TECHNICAL EVALUATION REPORT

FORT ST. VRAIN NUCLEAR GENERATING STATION

TECHNICAL EVALUATION OF THE PROPOSED REDUNDANCY REQUIREMENTS  
FOR HELIUM CIRCULATION TECHNICAL SPECIFICATIONS TO  
ACCOMMODATE THE RAPID DEPRESSURIZATION ACCIDENT

December 14, 1987

Figure 1. FSV Rapid Depressurization Accident from 82% power. Cooldown on one circulator with boosted firewater drive, minimum delay.

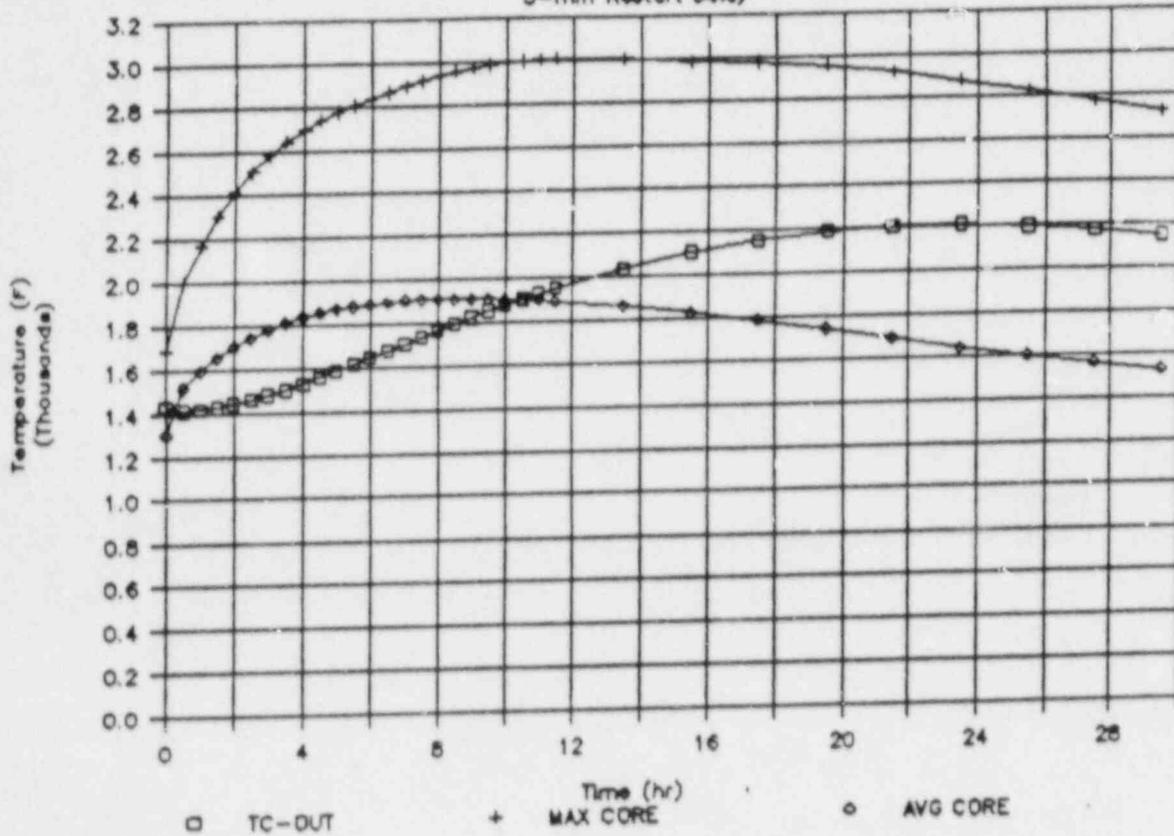
The independent analysis was done using the ORNL ORECA code, the pertinent features of which were described in a recent ORNL TER (Ref. 15). LCS cooling was assumed to be available. The forced circulation cooling flow estimated to be available for the (limiting) boosted firewater drive case was derived from Ref. 16, and was found to be 2.1 lbm/s, or ~0.22% of full rated flow. A parametric study was made for RDAs occurring from various power levels between 35% and 82%, and for minimum (5-min) and maximum (60-min) assumed delays in starting up the single circulator. In no case was the design temperature of the circulator exceeded. The results are summarized in Table 4 below, and an example of the calculated response (82% power, 5-min delay) is shown in Fig. 1.

As noted in the table, no fuel failure is predicted for RDAs from power levels up to 70% for the case where forced circulation is available with minimum delay (60% with maximum delay), and even for the worst case (82%, maximum delay), the fuel failure is only on the order of 1%. Thus, the risk from having to rely on boosted firewater instead of high pressure feedwater to provide forced cooling is lower than the dose rates given in Section 5 of this TER because only 1% as opposed to about 95% of the fuel is predicted to fail.
